UNITED STATES
ENVIRONMENTAL PROTECTION AGENCY
REGION III

PERMIT
FOR CORRECTIVE ACTION

GENERAL ELECTRIC COMPANY
COLUMBIA, MARYLAND
EPA ID NO. MDD046279311

**FINAL DECISION AND
RESPONSE TO COMMENTS**

Figure 5
Proposed Revised Permit Boundary
Former Appliance Park East Facility
Columbia, Maryland

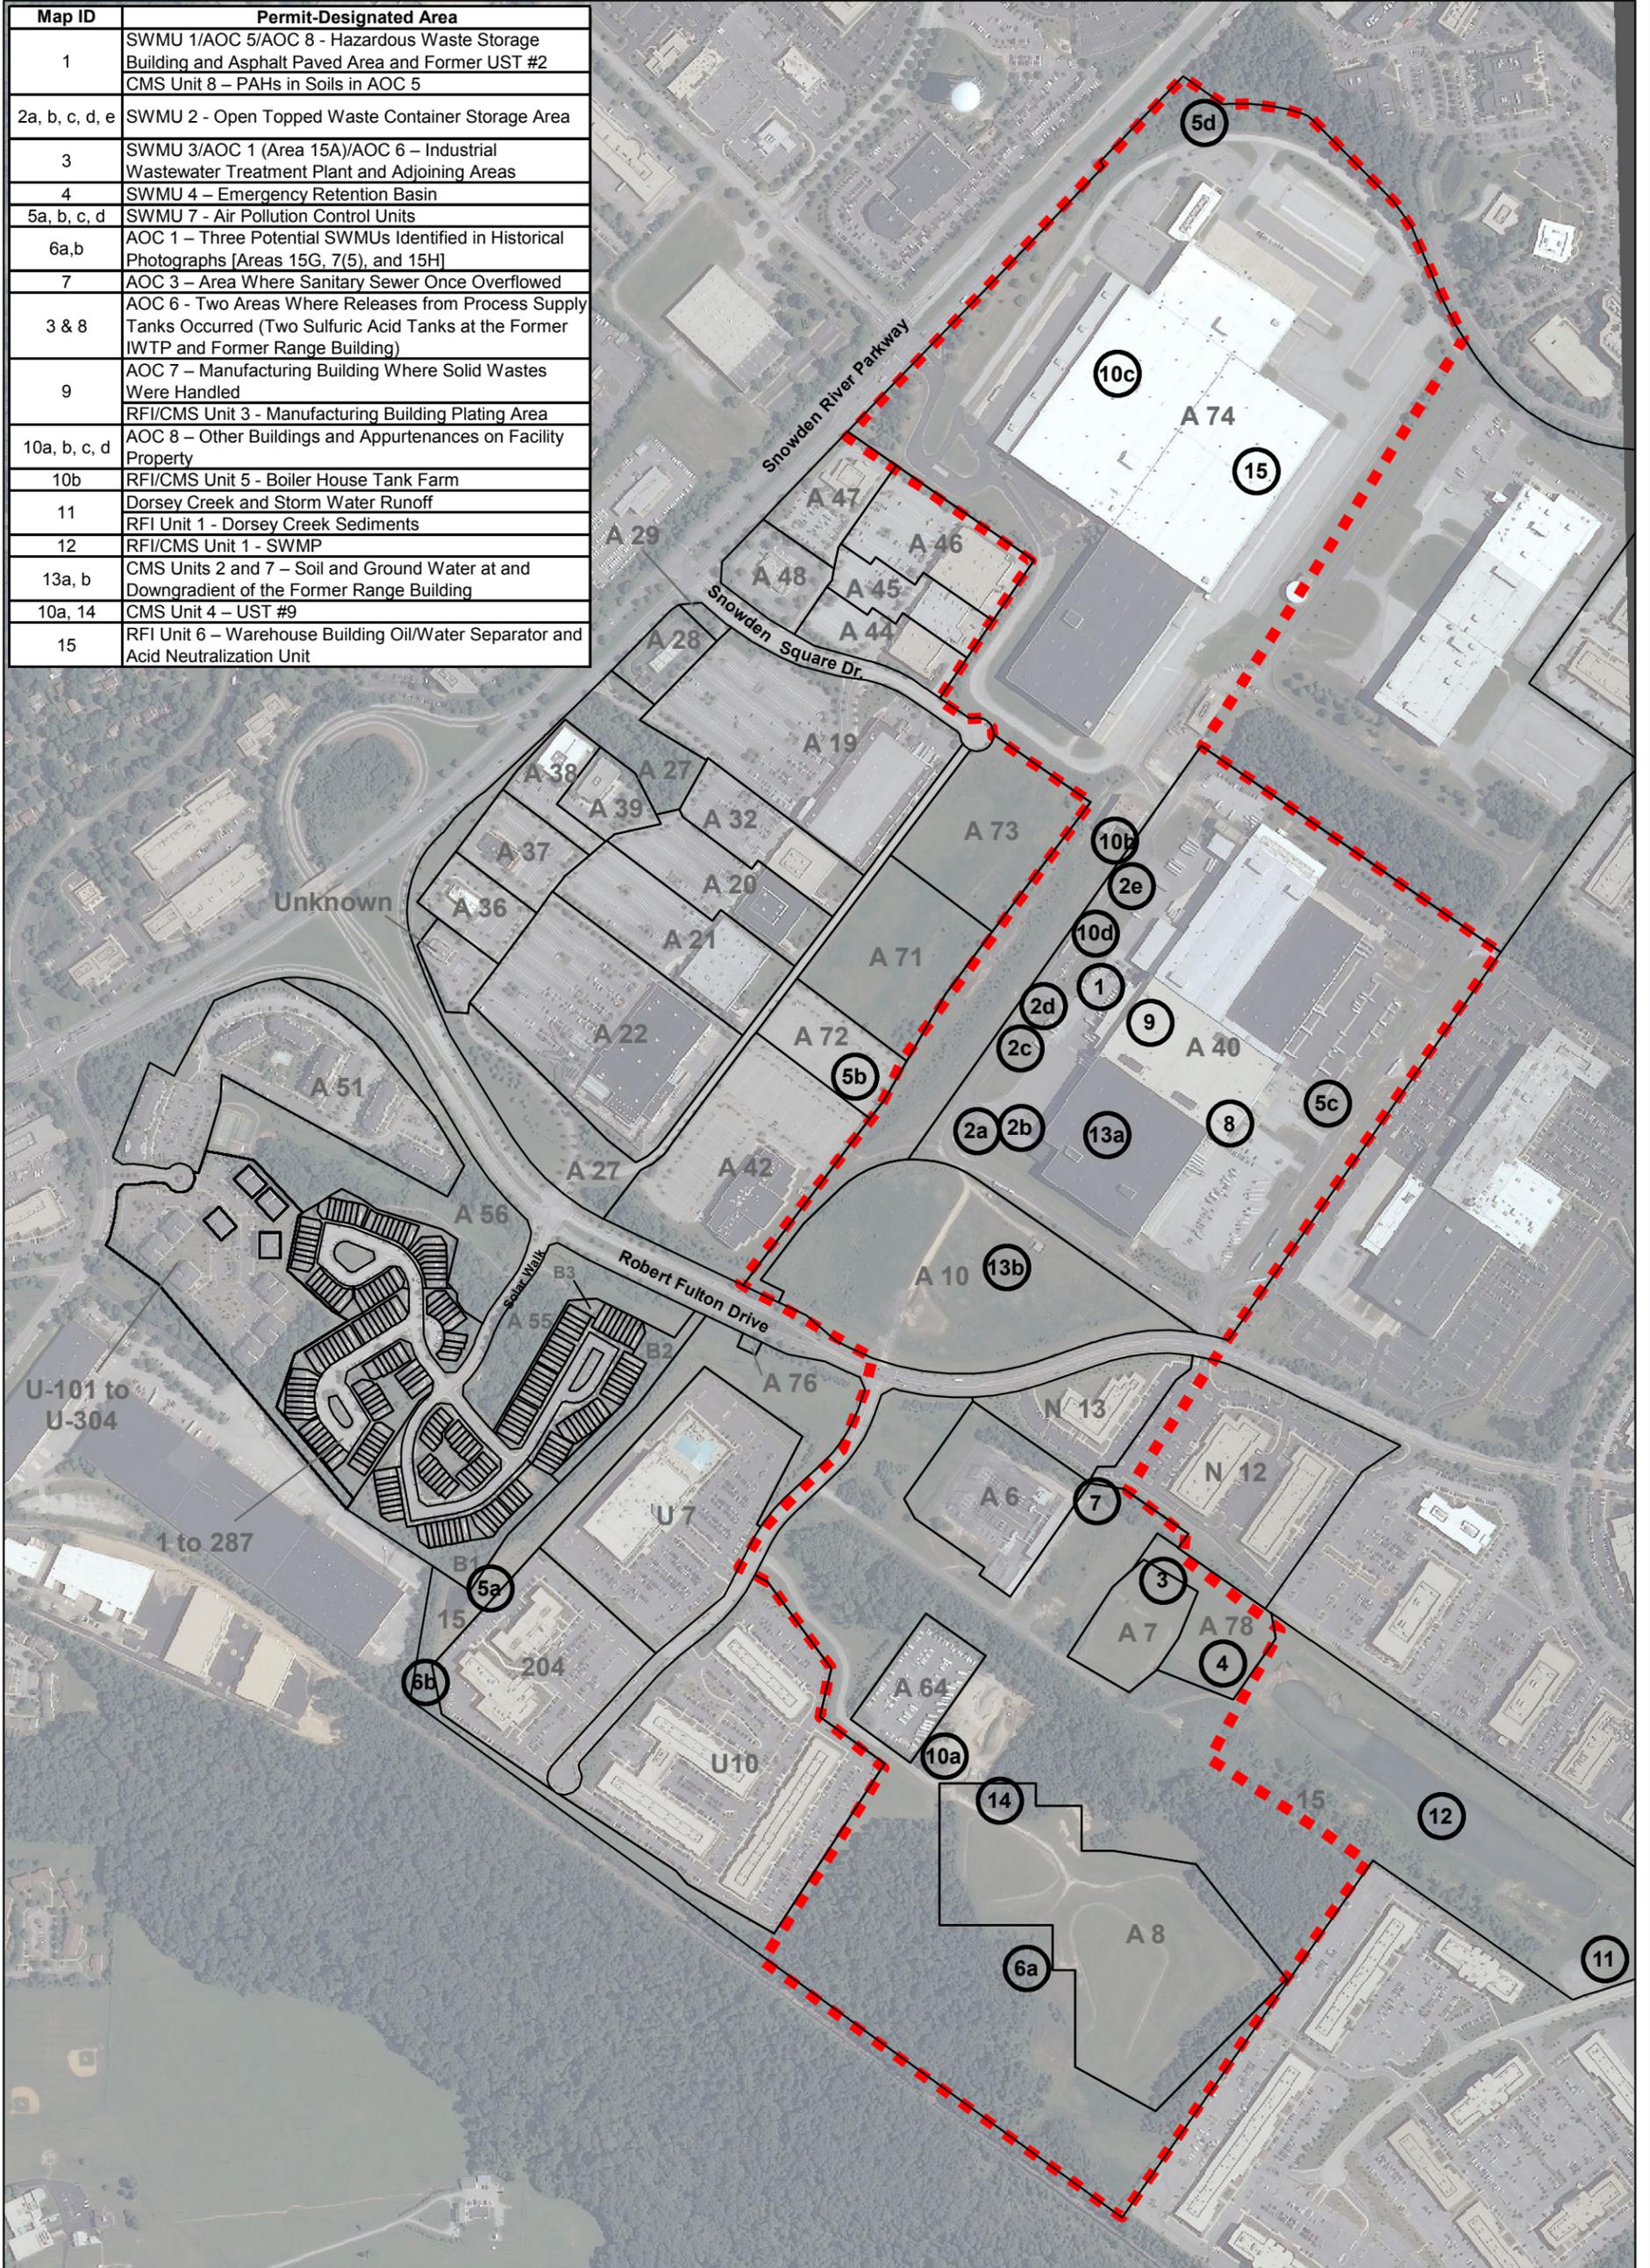
Reducing the facility boundary as shown in attached Figure 5 from the *Draft Corrective Action History Document* would eliminate more than 100 acres covered by the existing Corrective Action Permit, most of which have undergone significant physical changes since the permit was first issued in 1990. These areas include residential, retail and commercial land use, including restaurants (e.g., Ruby Tuesday, Bertucci's), a movie theater, public thoroughfares, and retail shops (e.g., Home Depot, Staples). The remaining contiguous acreage would continue to be covered by the renewed permit.

5. Consistent with Comment No. 1 above, GE recommends that the definition of the facility be included in Part IA of the permit. The attached Figure 5 can be used to support the revised facility definition in the renewed permit.

In response to the first subject of Comment Number 1 EPA has updated Figure 5 of the Statement of Basis to reflect the new boundary of the Facility subject to RCRA Corrective Action. The draft permit defined the Facility subject to Corrective Action as 452 acres. Since Corrective Action has been completed on the majority of the property EPA accepts GE's proposed Facility boundary (see Figure 5) and redefines the Facility boundary as those 228 acres containing Units with ongoing Corrective Action. In response to the second subject of Comment Number 1, EPA does not agree to remove condition I.B.13.a from the permit, as inclusion of this provision is required by 40 CFR § 270.30(l)(1).
